Our ref: HGY/2024/0141 Contact: John Kaimakamis Date: 13/09/2024
Town and Country Act 1990 (As amended)		
Location:	Mayfield House, St Anns General Hospital, St Anns Road, Tottenham, London, N15 3TH	
Proposal:	Partial approval of details (Phase 1A only) pursuant to Conditions 28(A) (Revised Energy Strategy) and 29 (Overheating) attached to Planning Permission Ref: HGY/2022/1833 dated 10 July 2023.	
Wording of condition 29:	Prior to the commencement of above ground works to Phase 1a, a Revised Overheating Model and report shall be submitted to and approved by the Local Planning Authority, based on acceptable principles as approved, taking into account any detailed design changes and responding the outstanding actions at application stage. The model will assess the overheating risk in line with CIBSE TM52 and TM59 (using the London Weather Centre TM49 weather DSY1-3 files for the 2020s, and DSY1 for the 2050s and 2080s) for the residential units and demonstrate how the overheating risks have been mitigated and removed through design solutions. This report will include: - Reconfirmed details of the design measures incorporated within the scheme in line with the Cooling Hierarchy (incl

Figure 4: Phase 1A site plan showing locations of dwellings selected for overheating assessment

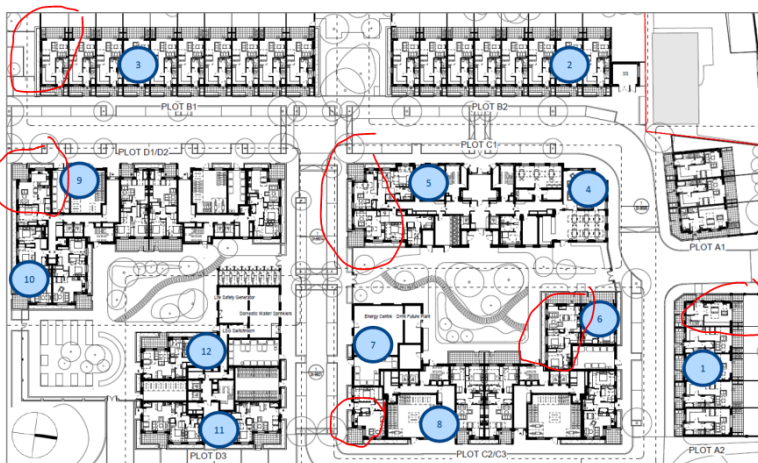
- What are the modelled heat gains in the flat from the HIU?
- The selection of dwellings modelled does not represent the worst-case dwellings in terms of overheating risk. No south-facing affordable units have been modelled, or south-west. Please model others, in line with the suggestions circled in red below.

- What are the modelled heat gains in the flat from the HIU?
- The selection of dwellings modelled does not represent the worst-case dwellings in terms of overheating risk. No south-facing affordable units have been modelled, or south-west. Please model others, in line with the suggestions circled in red below.
